INDESIT company

Model type:
IS60VEX

Commercial code:
F030637

N1040405FIG1

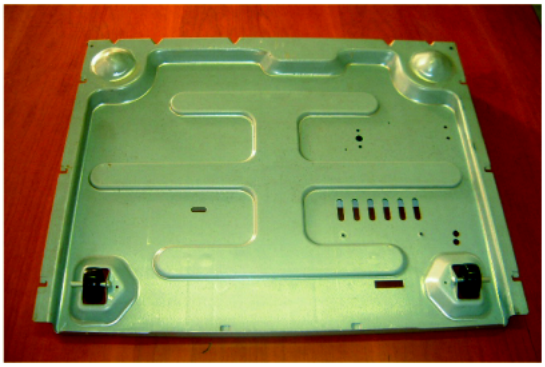
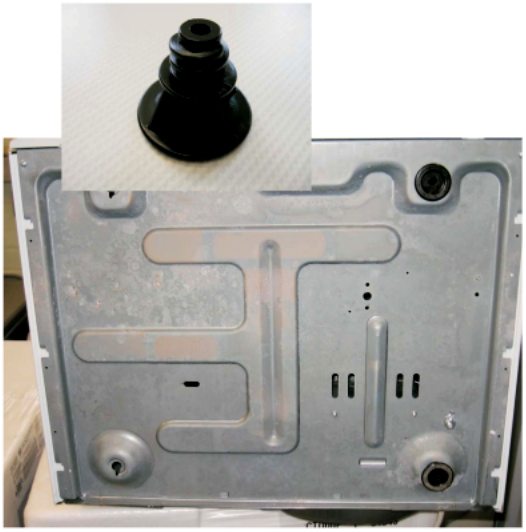
n1040405: Feet installed on dryers

Four feet have been installed on the dryers referred to in this release (see pictures N1040405FIG1-FIG2).

New parts
C00142439 - foot
C00142908 - base

premodification parts
C00095591 - wheel
C00095592 - pivot
C00112148 - base

Models/serial numbers affected by modification:
cc30632 - IS60VFR - s/n 51020.0001
cc30636 - ISL60NL - s/n 51102.0001
cc30637 - IS60VEX - s/n 51019.0001
cc30638 - ISL60VEX - s/n 51018.0001
cc30639 - IS60VSK - s/n 51018.0001
cc30640 - IS60VEXPAI - s/n 51018.0001
cc30651 - ASL60VEX - s/n 51110.0001
cc30652 - AS60VEX - s/n 51020.0001
cc30655 - AS60VSK - s/n 51020.0001
cc30657 - AS60VEX60HZ - s/n 51202.0001
cc33618 - ALE60VFR - s/n 51117.0001
cc36302 - AS60VXAUS - s/n 51024.0001

n4408c00: VENTED HEATER/THERMOSTATS

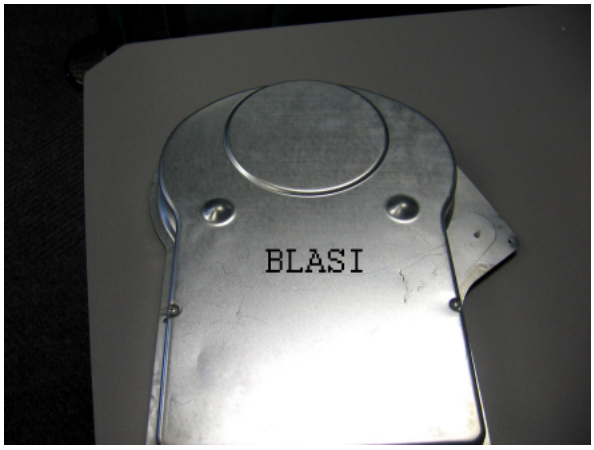
From Serial Number 70802.0001, two different heater manufacturers were used in production, DBK and Blasi. The DBK and Blasi Heaters are totally interchangeable if replaced as an assembly.

Attention,
The thermostat kits for these heaters are not interchangeable.

From Serial number 70802.0001. Before a Thermostat kit is replaced the type of heater as fitted to the machine must be first identified.

Identification,
The cover of the Blasi heater has 2 raised dome shaped pips, there is also a Blasi Label attached to the inside of the heater cover (photo N4408C00-BLASI).

The Cover of the DBK Heater has 4 raised dome shaped pips (photo N4408C00-DBK).

DBK heaters and covers are used as service spares, therefore if a heater or cover have previously been replaced further identification is required.

The DBK heater element wire is in a strip.
The Blasi heater element wire is circular.

Note.
For the Dryer to work correctly it is important that the correct Thermostat Kit is always fitted.

n4410i00: Introduction of Welling Type 358 Motor

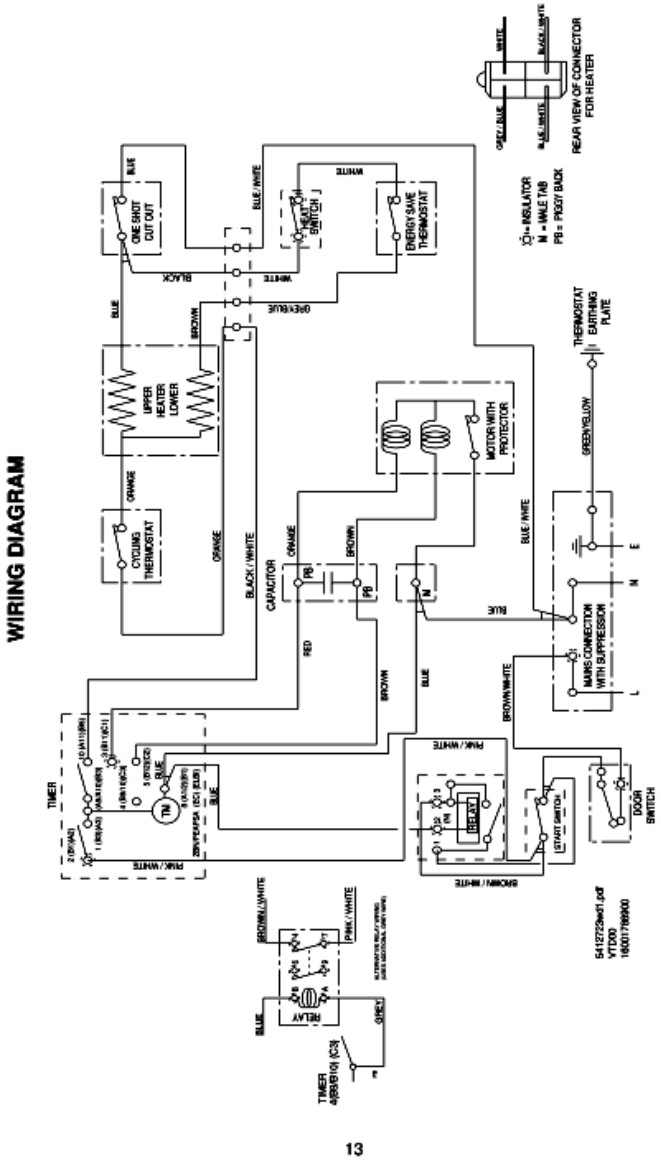
From 17/08/2010 serial No.00817.0001 production started to use a type 358 motor manufactured by Welling, this motor uses a 9µf capacitor.

The Welling 358 motor can be used as an alternative to the previous 358 type motor manufactured by IMEP but a 9µf capacitor must also be fitted.

CAPACITORS
Ana Imep motors had 7.5uf,(6kg models) 8.0uf (7kg models) or 9uf Capacitirs (7.5kg models), fitted in production.
A 9uf capacitor can be used as the service replacement for all machines fitted with a Ana Imep motor.
Welling 358 motors must only be fitted with a 9uf Capacitor.

BOTH 358 MOTORS ARE INTERCHANGEABLE PROVIDING THE CORRECT CAPACITOR IS FITTED
